PATENT USSN: 10/585,994

REMARKS

FIG. 1

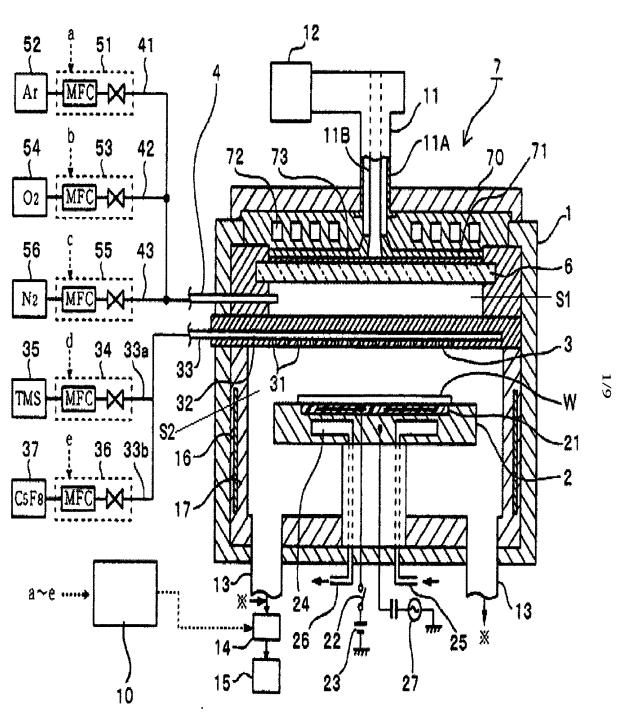
The Examiner objected to the Drawings for failing to include reference signs S1 and S2.

Applicants respectfully submit that the amendment to Figure 1, as set forth in Replacement Sheet 1/9, provides reference signs S1 and S2. No statutory new matter has been added by Replacement Sheet 1/9. Therefore, the amendment to the Drawings should be entered and the objection to the drawings should be withdrawn.
